State of Wisconsi Department of Na dnr.wi.gov	il - Hiawatha Passage Motorized Recreation Grant Application For: (choose all that apply) ATV/UTV Trail Aid Page 1 of 5												
Due Date: Apr	 ✓ ATV/OTV Trail Aid ✓ Snowmobile Trail Aid ✓ Motorized Stewardship - 20% County match required 												
financial assistance	n of this form is req e. Personally identit (DNR) may provide	fiable infor	mation	found	on this forn	n is not i	ntended to b	e used t	for any other	purpose	. The [Department of	
be submitted for Stewardship fund	oplications may co consideration of tr ling. Submit one c ments. Send appli	JTV, S and a	e and Motorized Category Number s. See Page 2 for										
Section 1: App	licant Informatio	n	175	E				TENZ		S In lie	BA		
Applicant / Organ	ization Name					Check Recipient: Individual other than authorized individual to act							
Vilas County Pa	arks and Recrea	tion				on behalf of the applicant.

Vilas County is proposing to construct a new Summer ATV/UTV trail and re-locate a portion of the current snowmobile trail. A wider trail base will be established in the USH 45 Row to accommodate at least a 10' set back from the roadway and for a 14' wide trail required by t

INO.	DATE	REVISION	Вī	1		
PROJECT DATE: .	DRAWN BY: JMP			·				
	DESIGNED BY: PJK			· _		ı ((
	CHECKED BY: SM			. "		7		
PLOT DATE: 7/19/2022 2:56 PM, G\11\11652\11652006\CADD\C3D\11652006 Hiawatha ATV Plan & Profile.dwg

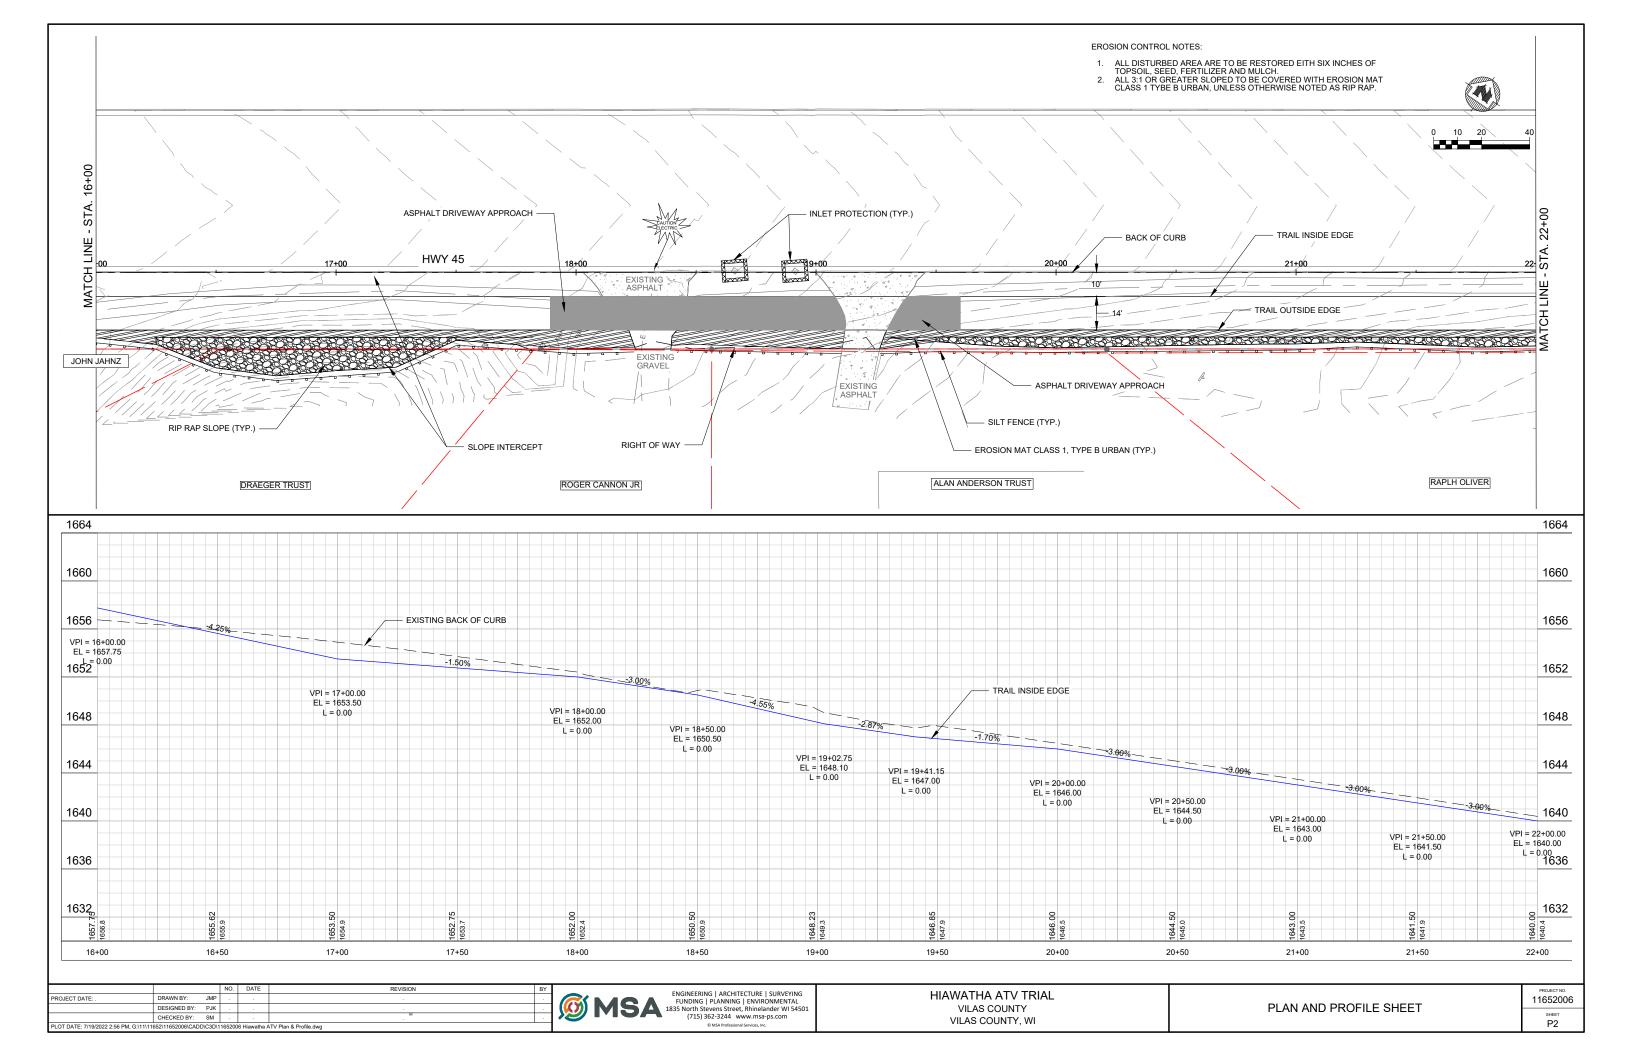
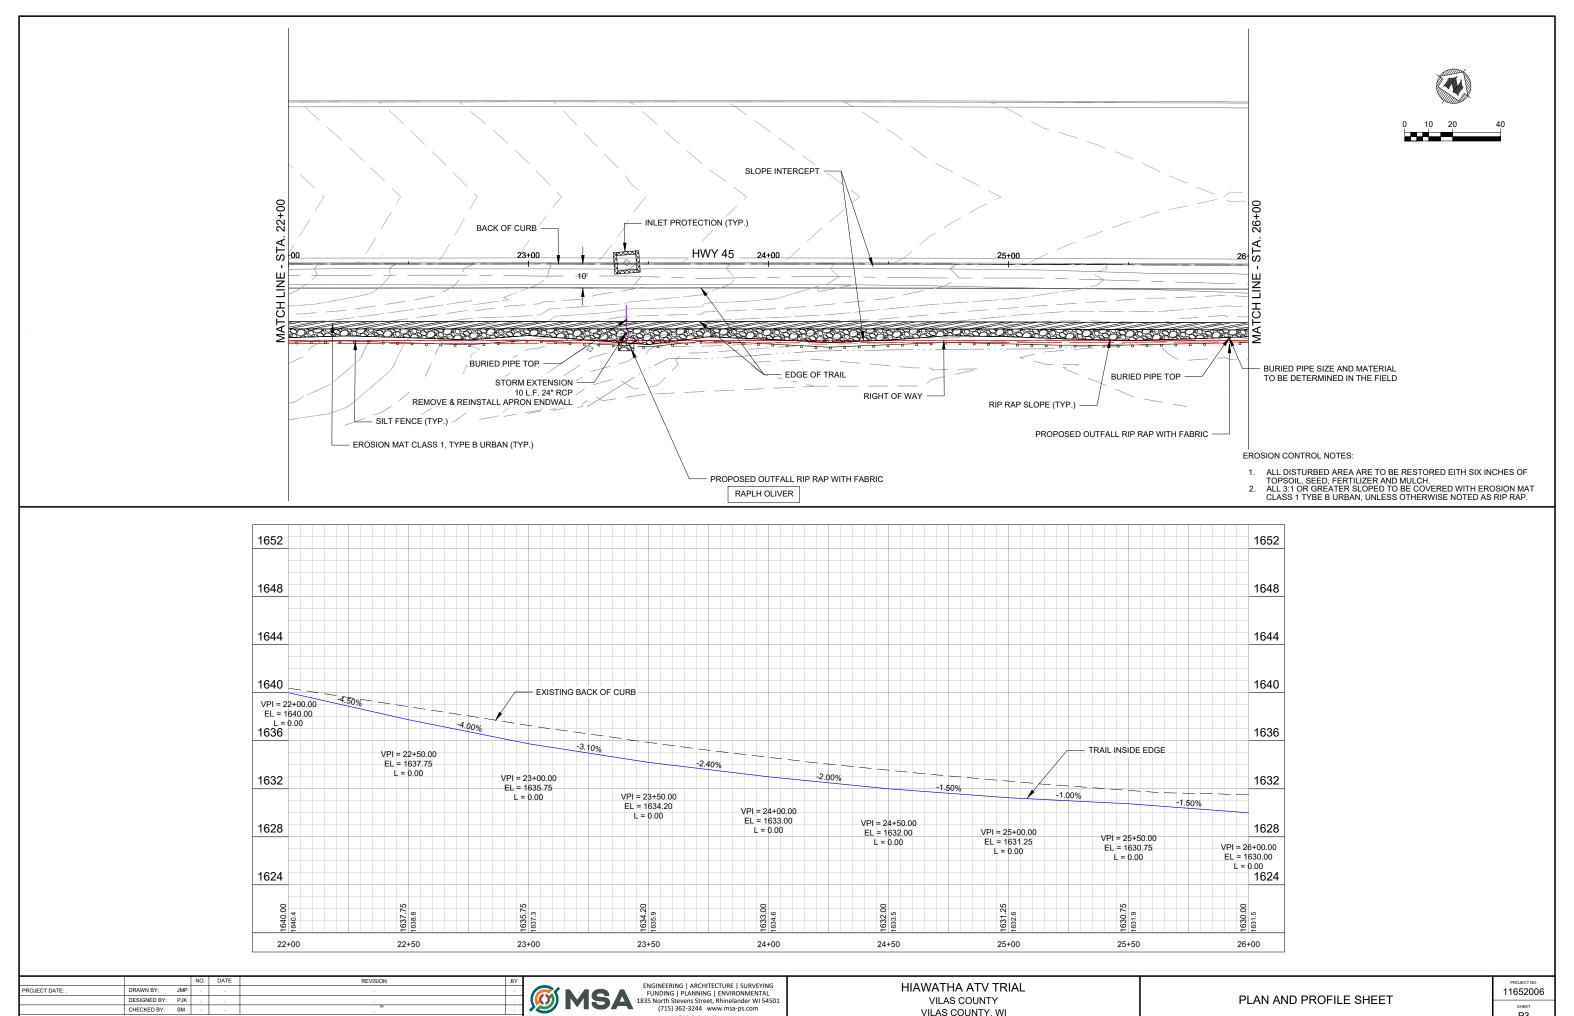
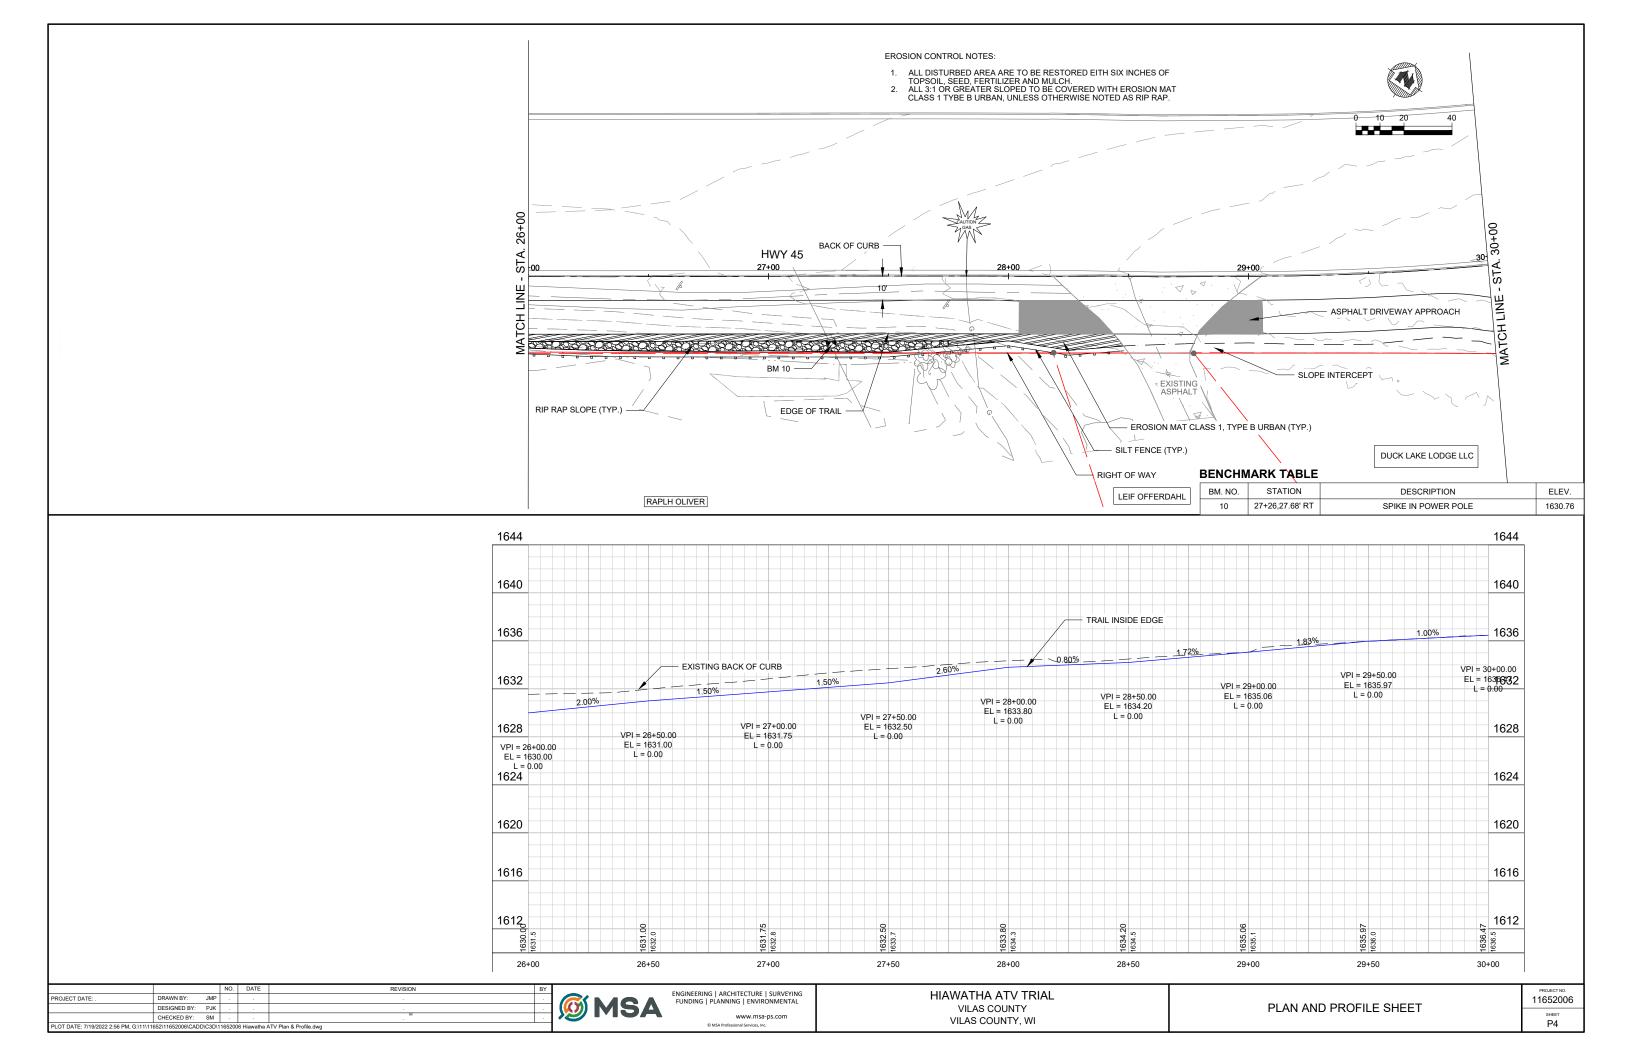
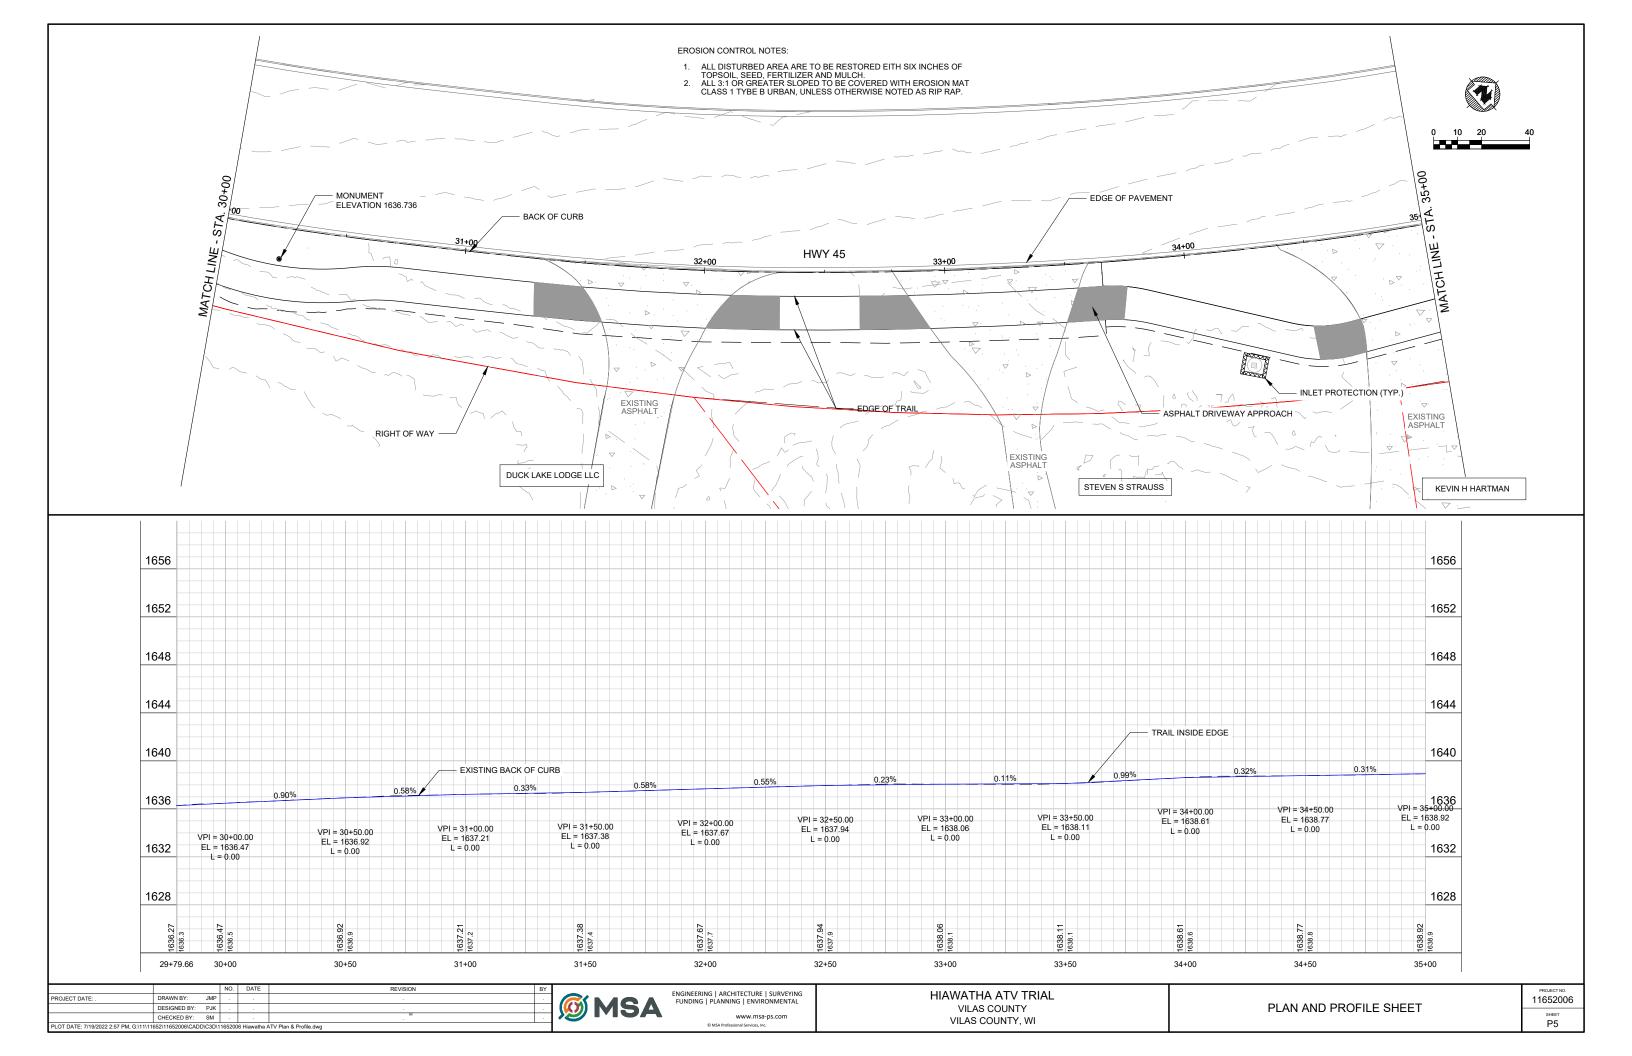
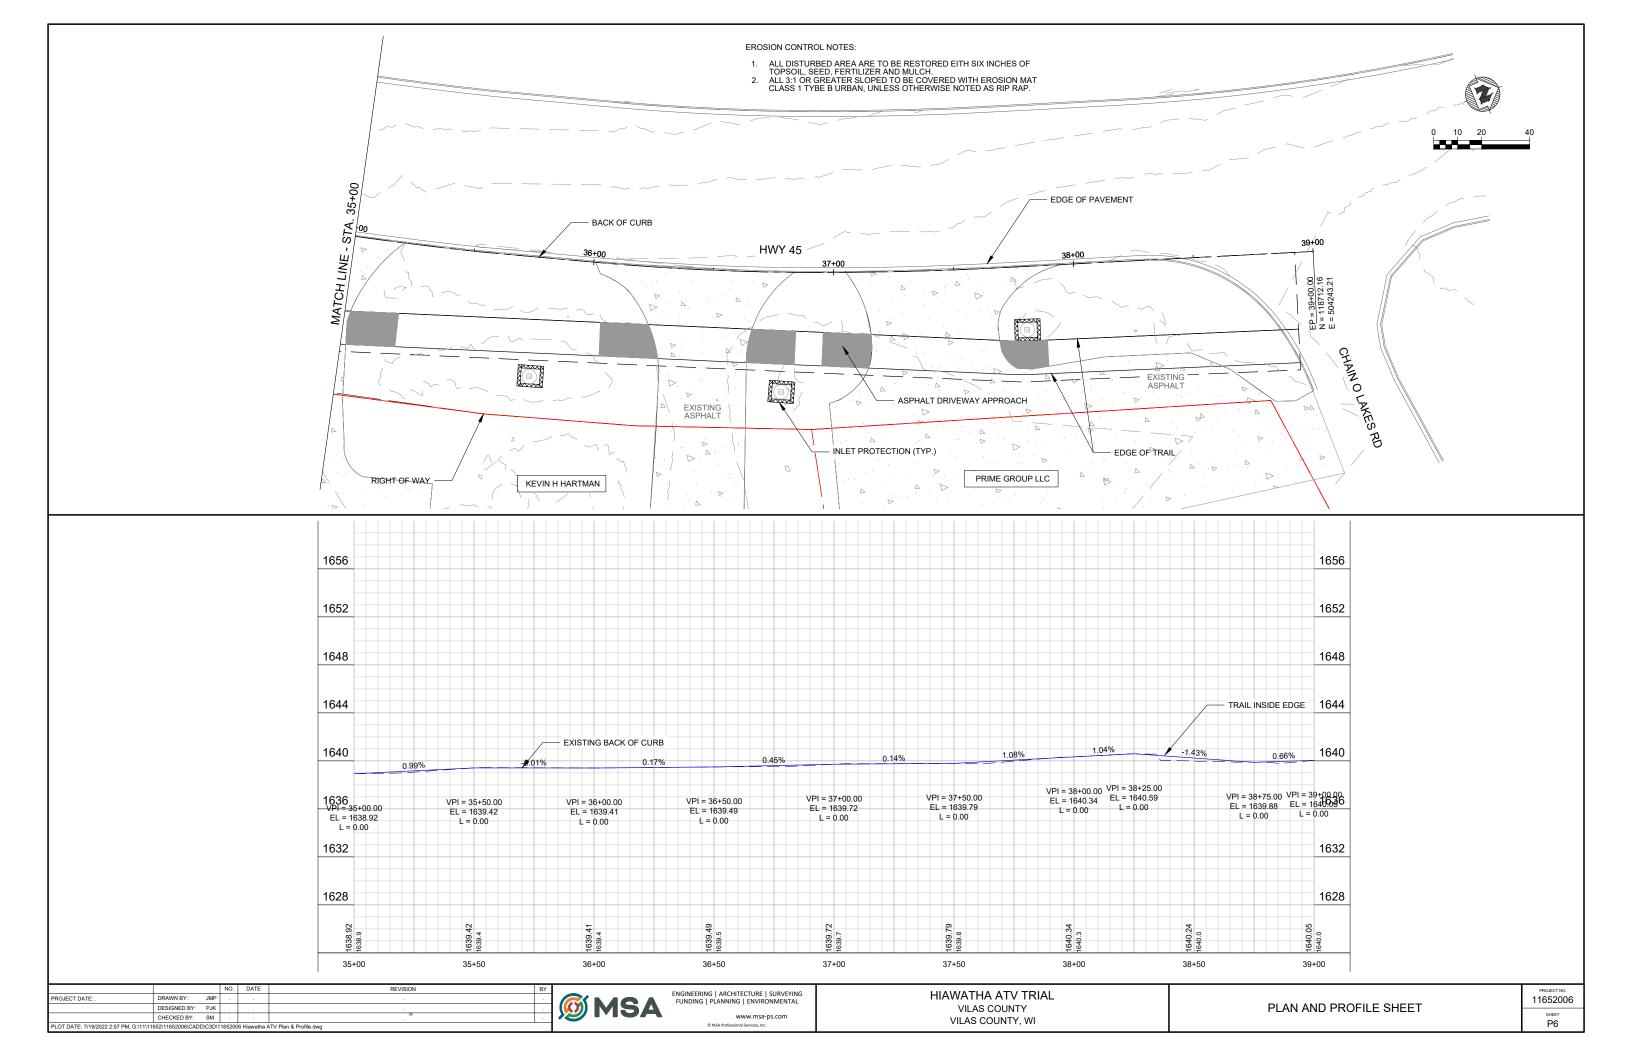
Thank you for the submittal. One item that needs to be discussed prior to a full review of the trail segment is trail connectivity. It appears that the trail is planned to end at a private road to Hiawatha Condos on the north end of the trail. This is problematic because WisDOT policy does not allow for ATV trail permitting that serves private business with no route/trail interconnectivity. The logical end point of the trail is Chain O Lakes Road to the north. The other concern is that it appears that there is some illegal ATV use of the right of way today between Hiawatha and Chain O Lakes Road. Construction of an ATV trail without including this area in the trail planning will result in increased illegal use of the US 45 right of way, and associated maintenance and safety concerns. WisDOT will require additional consideration for trail extension to Chain O Lakes Road, or some other logical terminus, prior to being able to fully review a planset and approve a trail permit.

- 1. 10-foot setback from the back of curb.
- 2. A maximum slope of 6:1 in the 10-foot setback from the curb and gutter to the trail.
- 3. A 14-foot wide 6-inch thick gravel trail with a 2% cross slope normal and maximum cross slope of 4% to match the driveways.
- 4. A 3:1 slope on the right side for 3-feet. After the 3-feet we vary from 3:1 with vegetation to a 1.5:1 with riprap.

The slope intercepts do drift out of Right of Way on the Johnz, Draeger Trust, and Oliver properties. The County would need to approach these landowners about the work out of the right of way. Would the DOT require the County to acquire easements for the disturbance?

The existing storm sewers at 23+40 would need to be extended. Currently the storm sewer at 23+40 end wall is partially plugged with sod. The storm sewer at 25+92 is completely plugged with vegetation from the wetland and should be cleaned out. The inlet in the curb at 25+92 show signs of water overtopping the curb and running to the wetland. If required a safety fence could be installed at the end of the 3:1 slope allowing a 3-foot clear area from the trail.

Wetland fill permit may be required. Todd you may want to reach out to the DNR with the preliminary plans and get their feedback. We are very close from 25+50 to 26+25.

Thanks for the information, maps and plans. I remember being on site with you last year and seeing the wetlands adjacent to the proposed trail area immediately off the roadway's slope. I agree with Phil's statement that must figure out where exactly that wetland boundary is (by a wetland delineation), and then if any fill material is to be placed within the wetland this will require DNR Wetland Disturbance – Recreational Development permitting. I would say the next step is to get a Wetland Delineation completed to flag this wetland boundary, overlay the project design to that delineation report, and calculate that amount of fill (in square feet). If no fill will be placed within the wetlands, then DNR Wetland Disturbance permitting will not be required. I know we discussed constructing an elevated boardwalk thru this area to avoid wetland disturbance, but this is very costly and that must be explained in the Practical Alternative Analysis submitted with the Wetland Disturbance permit, all options considered to avoid and reduce wetland impacts (ie: elevated boardwalk, trail routed elsewhere, etc..).

Thanks Phil – I think the revised plan is enough that we can circulate for internal review. A couple more comments:

- 1) We will need a complete, up to date trail application[*Todd Bierman*] This will be completed in late winter of 2023. Will send it to you when completed.
- 2) Signing plans will be needed I will get this completed in the near future and send you a copy.
- 3) In areas where the trail encroaches on private property, we will need evidence of landowner coordination and lease/approval I will get this to you from the club.
